TECHNICAL SERVICE BULLETIN NO. 2519

Honda Clutch Disc 717-08004

Figure 1

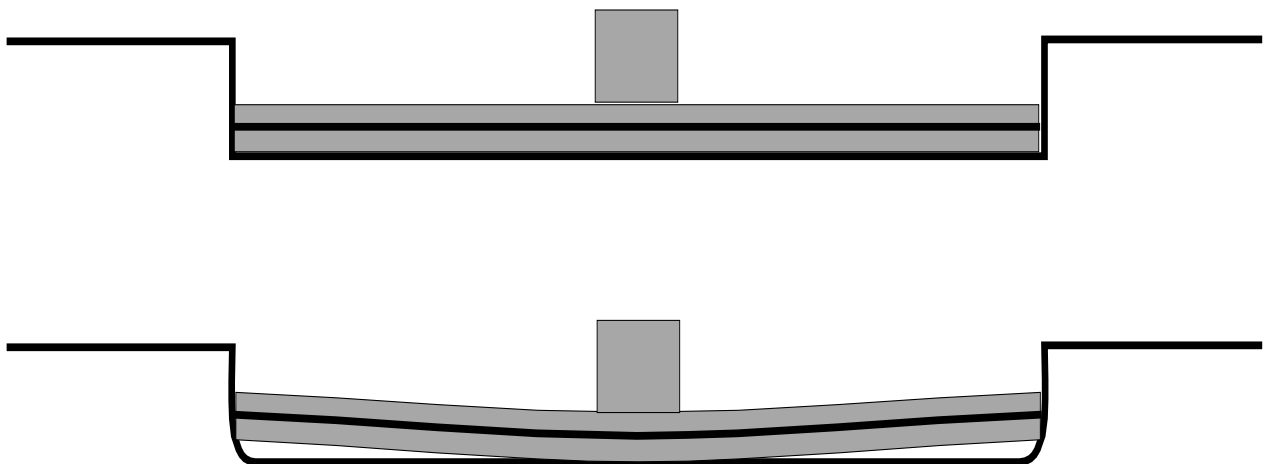
Depending on which manufacturer you order from, clutch disc 717-08004 can be supplied in diameters varying from 212mm to 215mm. The pressure plate and flywheel are 215mm. There have been complaints from some installers concerning chatter and slipping on this application. This is the reason for trying a smaller clutch disc. The 215mm version affords the driver a larger friction surface, increasing heat dissipation and extending the life of the clutch over smaller discs. In researching these complaints, it was found that improper resurfacing or failure to resurface the flywheel when using the larger disc was the problem. Improper resurfacing of the flywheel left either tapered sides on the flywheel step and/or an excessive radius in the bottom corner of the flywheel step. (Figure 1) This causes the larger clutch disc to contact the flywheel on only the outer edge of the flywheel, resulting in slipping or chatter. This continues until the disc wears enough of the flywheel for the disc to sit flat. To avoid this problem when installing any new clutch assembly on a stepped flywheel, be sure to closely inspect the fit of the sides and corners.
